গণপ্রজাতন্ত্রী বাংলাদেশ সরকার
শ্রম ও কর্মসংস্থান মন্ত্রণালয়
কলকারখানা ও প্রতিষ্ঠান পরিদর্শন অধিদপ্তর

ক্যাপ পর্যবেক্ষণের তথ্য

কারখানার নাম	ওয়েল টাচ এ্যাপারেলস লি:
ঠিকানা	234/1, Kochukhet, Vasantek, Mirpur, Dhaka-1206.
কারখানার কোড	DHK629
কালার কোড	
মূল্যায়নের ধরণ: কাঠামোগত মূল্যায়ন	পর্যবেক্ষণের তারিখ: ০৫-০৪-২০২৩
১. পর্যবেক্ষণ

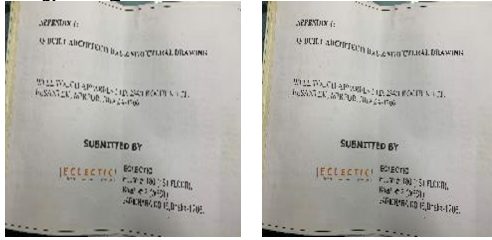
পরিদর্শন পর্যবেক্ষণ	There are 20 additional columns irregularly constructed, marked in the following layout plan, which seem to be illogical.
ক্যাপ আইটেম ক্যাটাগরি

কার্যক্রম	Building engineer to check and verify that the additional columns, existing building frame has sufficient capacity to carry factory imposed load.
সুপারিশের ভিত্তিসূত্র	
কারখানার কার্যক্রম	Building engineer will check load carrying capacity of building.
অগ্রাধিকার	৬ সপ্তাহ
চূড়ান্ত সময়সীমা	২১-০৯-২০১৬
সংশোধিত সময়সীমা	০১-০১-১৯৭০
অগ্রগতির অবস্থা	শুরু হয়নি
মন্তব্য	06/07/2020: This issue is related to DEA. Factory management appoint a consultant (ECLECTIC) for DEA. DEA work process is ongoing. 03.11.2020: DEA is not submitted yet. 01.02.2021: DEA work has been not started yet. 18/08/2021:There was no DEA & structural analysis available on site. 10/08/2022: DEA report should be prepared and submitted to DIFE as soon as possible. 05/04/2023: DEA report should be prepared and submitted to DIFE as soon as possible.

কার্যক্রম	Building engineer to assess the building structure with regard to lateral wind and seismic resistance.
সুপারিশের ভিত্তিসূত্র	
কারখানার কার্যক্রম	Engineer will check the lateral stability of the building.
অগ্রাধিকার	
চূড়ান্ত সময়সীমা	২১-০৯-২০১৬
সংশোধিত সময়সীমা	-
অগ্রগতির অবস্থা	শুরু হয়নি
মন্তব্য	06/07/2020: This issue is related to DEA. Factory management appoint a consultant (ECLECTIC) for DEA. DEA work process is ongoing. 03.11.2020: DEA is not submitted yet. 01.02.2021: DEA work has been not started yet. 18/08/2021:There was no DEA & structural analysis available on site. 10/08/2022: DEA report should be prepared and submitted to DIFE as soon as possible. 05/04/2023: DEA report should be prepared and submitted to DIFE as soon as possible.

কার্যক্রম	Carry out any structural alterations as advised by the Structural engineer.
সুপারিশের ভিত্তিসূত্র	
কারখানার কার্যক্রম	Proper action will be taken by the Engineer.
অগ্রাধিকার	
চূড়ান্ত সময়সীমা	০৯-০২-২০১৭
সংশোধিত সময়সীমা	০১-০১-১৯৭০
অগ্রগতির অবস্থা	শুরু হয়নি
মন্তব্য	06/07/2020: This issue is related to DEA. Factory management appoint a consultant (ECLECTIC) for DEA. DEA work process is ongoing. 03.11.2020: DEA is not submitted yet. 01.02.2021: DEA work has been not started yet. 18/08/2021:There was no DEA & structural analysis available on site. 10/08/2022: DEA report should be prepared and submitted to DIFE as soon as possible. 05/04/2023: DEA report should be prepared and submitted to DIFE as soon as possible.

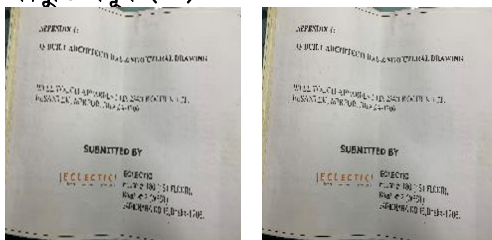
পরিদর্শন পর্যবেক্ষণ	Undocumented additional storey has been observed in the Building.
ক্যাপ আইটেম ক্যাটাগরি

কার্যক্রম	The Building Engineer shall provide calculations showing the structural adequacy of all columns taking into account any additions to the existing structure, the loading plans and as built structure.
সুপারিশের ভিত্তিসূত্র	
কারখানার কার্যক্রম	Structural adequacy of the building will be checked by the Engineer.
অগ্রাধিকার	৬ সপ্তাহ
চূড়ান্ত সময়সীমা	২১-০৯-২০১৬
সংশোধিত সময়সীমা	০১-০১-১৯৭০
অগ্রগতির অবস্থা	চলমান
মন্তব্য	06/07/2020: This issue is related to DEA. Factory management appoint a consultant (ECLECTIC) for DEA. DEA work process is ongoing. 03.11.2020: DEA is not submitted yet. 01.02.2021: DEA work has been not started yet. 18/08/2021: There was no DEA & structural analysis available on site but as built architectural & structural drawing were available on site. 10/08/2022: DEA report should be prepared and submitted to DIFE as soon as possible. as built architectural & structural drawing were found during inspection date. 05/04/2023: DEA report should be prepared and submitted to DIFE as soon as possible. as built architectural & structural drawing were found during inspection date.

কার্যক্রম	Building Engineer to survey and prepare as-built drawings for additional structure.
সুপারিশের ভিত্তিসূত্র	
কারখানার কার্যক্রম	All drawings will be prepared by the Engineer.
অগ্রাধিকার	
চূড়ান্ত সময়সীমা	০৯-০২-২০১৭
সংশোধিত সময়সীমা	০১-০১-১৯৭০
অগ্রগতির অবস্থা	চলমান
মন্তব্য	06/07/2020: As built drawing is completed and submitted to DIFE. 03.11.2020: As built structural and architectural drawing has been found on site. 01.02.2021: As built structural and architectural drawing has been found on site. 18/08/2021: As built architectural & structural drawing were available on site 10/08/2022: DEA report should be prepared and submitted to DIFE as soon as possible. As built architectural & structural drawing were found during inspection date.
